SANITARY SEWER LAYOUT
LANKIN ADDITION
May, 1969
R.S. DELAMATER
CONSULTING ENGINEER
WICHITA, KANSAS

We are handing you herewith the tracings for the 48" storm sewer and the sanitary sewer which have been constructed to serve the Lankin Addition.

These tracings have been corrected to indicate the grades and dimensions as built and also to include the connecting lines into the sewers; in the case of the storm sewer we have indicated the location, flowline and grate elevation of the inlets which discharge into the manhole at the eastern end of the line.

48" STORM SEWER LAYOUT
LANKIN ADDITION
May, 1969
R.S. DELAMATER
CONSULTING ENGINEER
WICHITA, KANSAS

48" STORM SEWER LAYOUT
LANKIN ADDITION
May, 1969
R. S. DELAMATER
CONSULTING ENGINEER
WICHITA, KANSAS

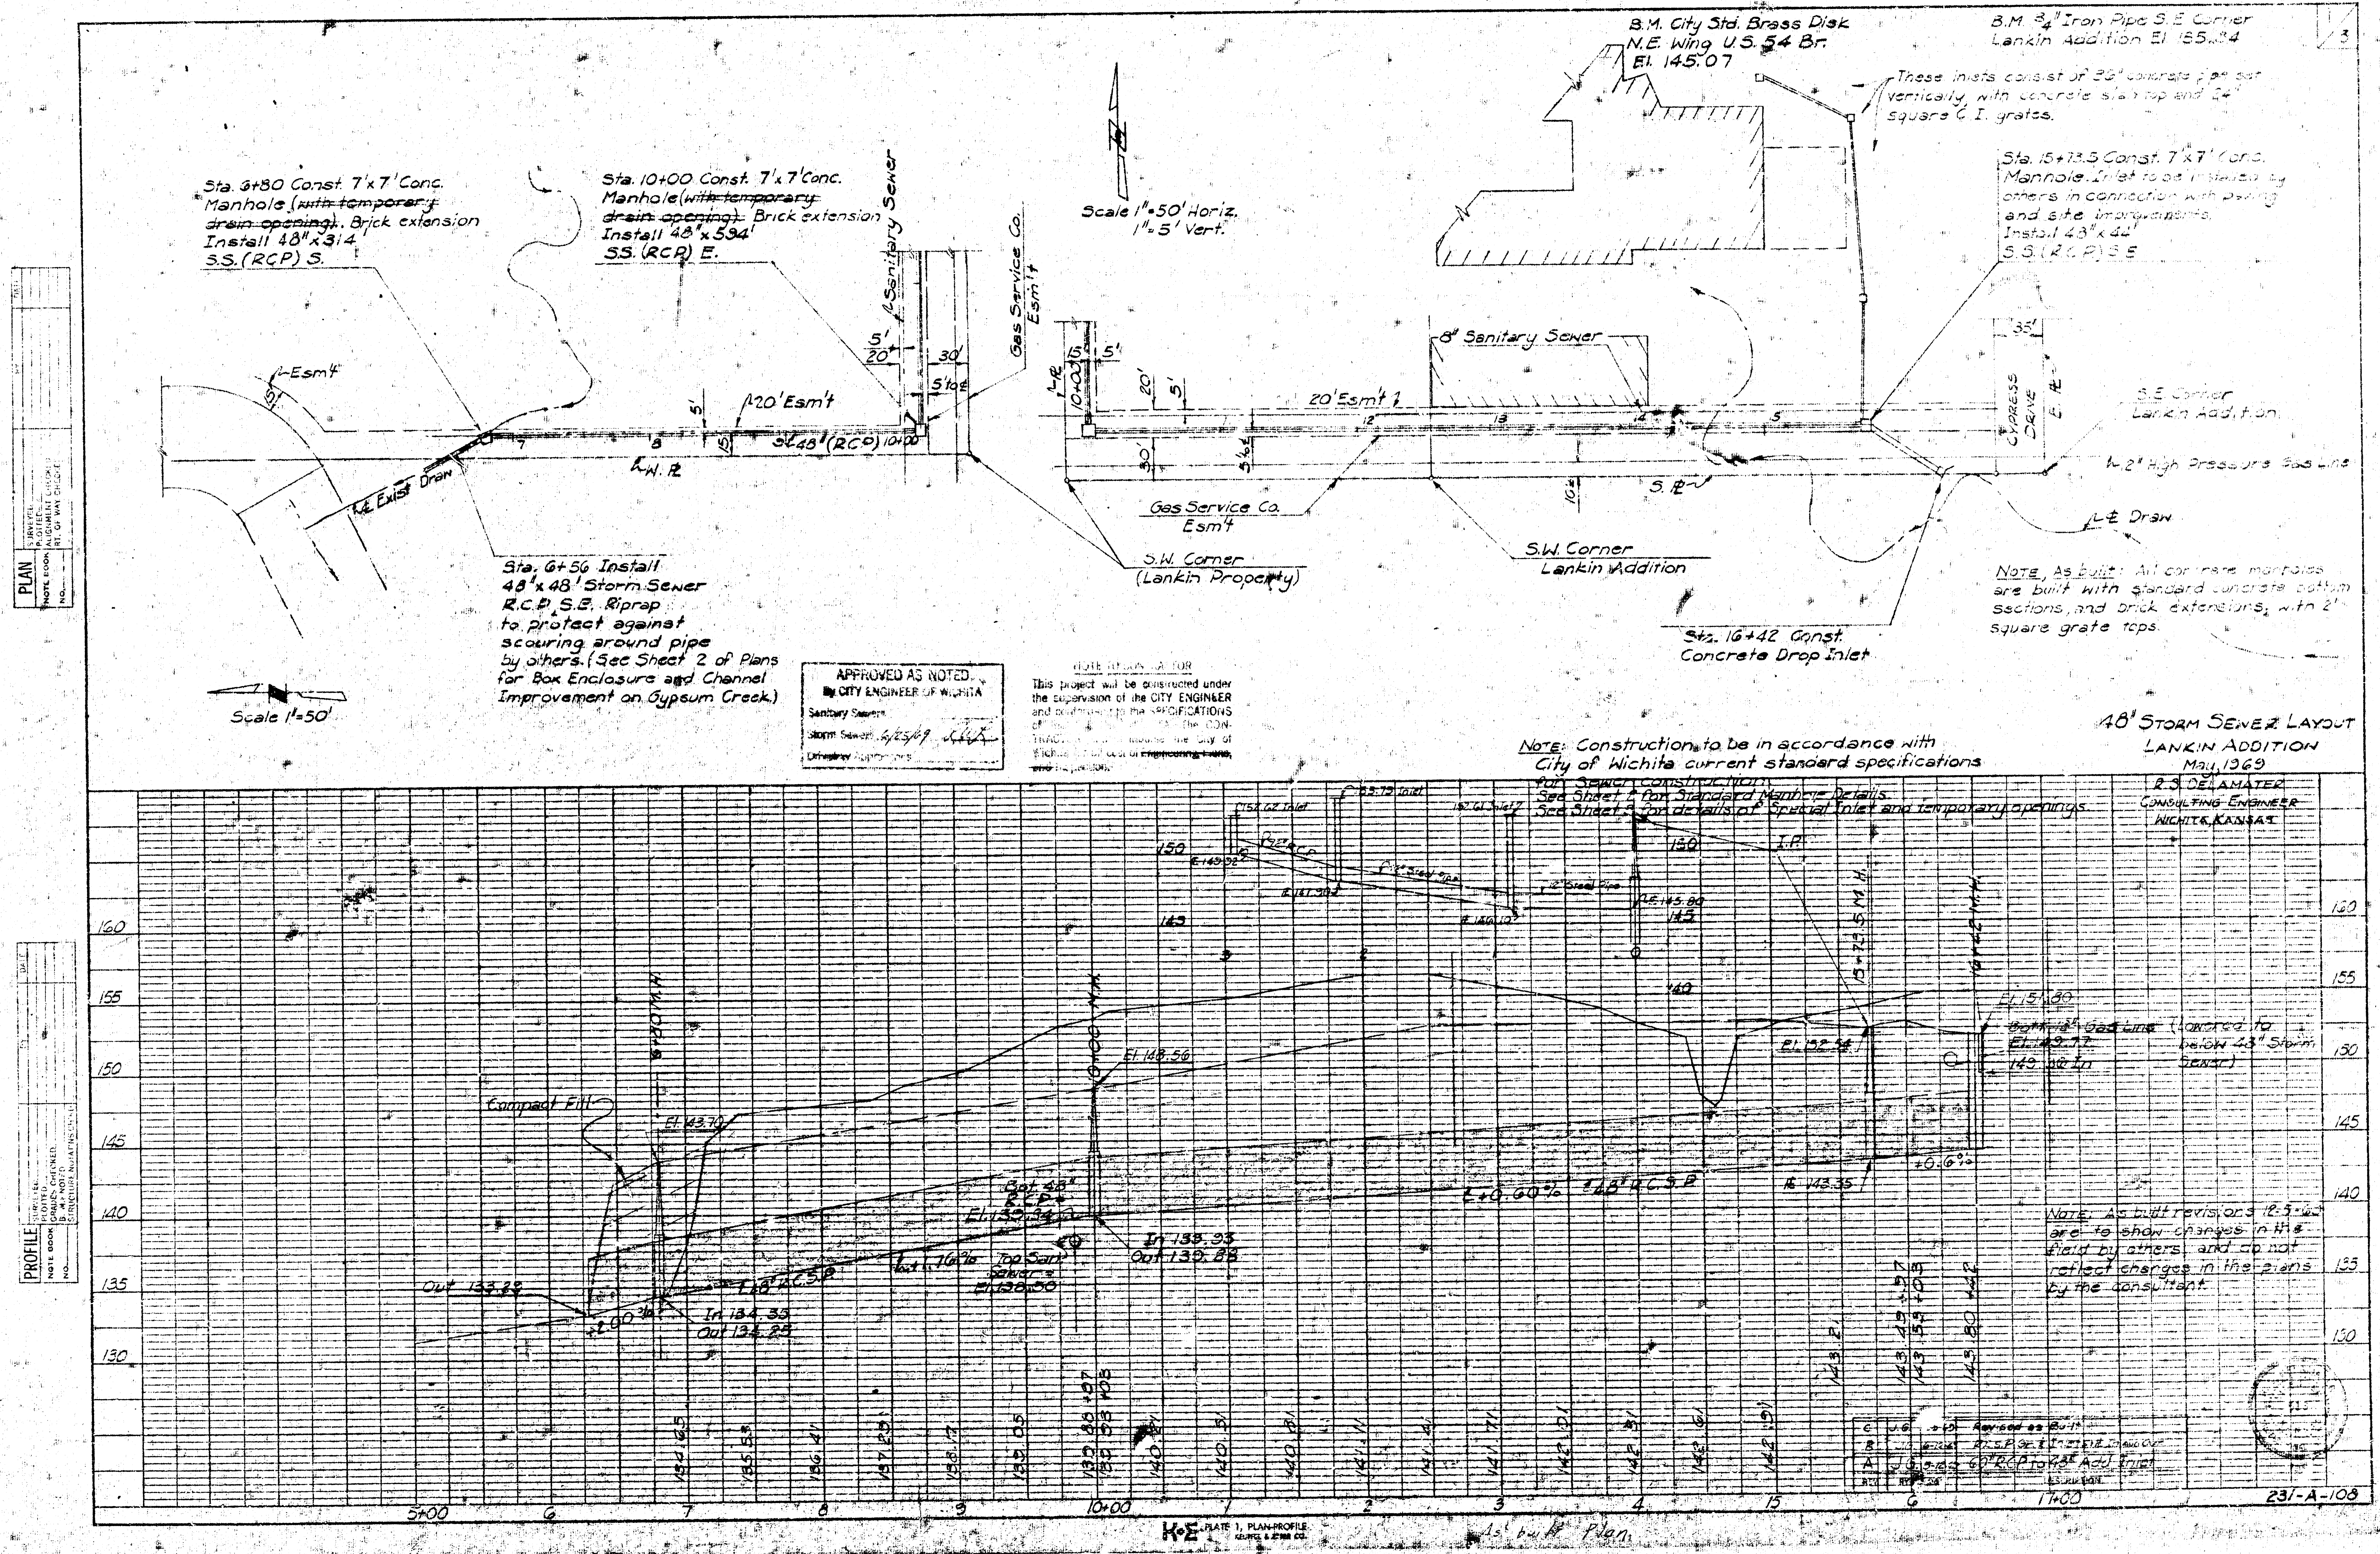
Sta. 6+56 Install 48" x 48' Storm Sewer R.C.P. S.E. Riprap to protect against scouring around pipe by others. (See Sheet 2 of Plans for Box Enclosure and Channel Improvement on Gypsum Creek.)
Scale 1"=50'
Sta. 16+42 Const. Concrete Drop Inlet
Note: As Built: All concrete manholes are built with standard concrete bottom sections, and brick extensions, with 2' square grate tops.
Compact Fill
El. 143.70
Out 133.89
In 134.35
Out 134.25
48" R.C.S.P.
+0.76%
Top Soil Sewer El. 136.50
Bot. 48" R.C.P. El. 135.34
El. 148.56
In 135.93
Out 135.88
+0.60% 48" R.C.S.P.
El. 143.35
+0.6%
El. 152.62 Inlet
12" Steel Pipe
El. 145.80
I.P.
El. 151.80
Bottom 12" Gas Line El. 149.77 (Lowered to below 48" Storm Sewer)

149.86 In
15+73.5 M.H.
16+42 M.H.
6+80 M.H.
10+00 M.H.
Note: As built revisions 12-5-69 are to show changes in the field by others and do not reflect changes in the plans by the consultant.
160
155
150
145
140
135
130

134.85
135.53
136.41
137.29
138.17
139.05
139.93
140.81
141.11
141.71
142.01
142.31
142.61
142.91
143.21
143.49
143.59
143.80
5+00
6
7
8
9
10+00
1
2
3
4
15
6
17+00
C J.G. Revised as Built
B J.G. R.C.S.P. Sc. Inlet In and Out
A J.G. 5-12-69 60" RCP to 48" Adj. Inlet
REV. BY DATE DESCRIPTION
231-A-108
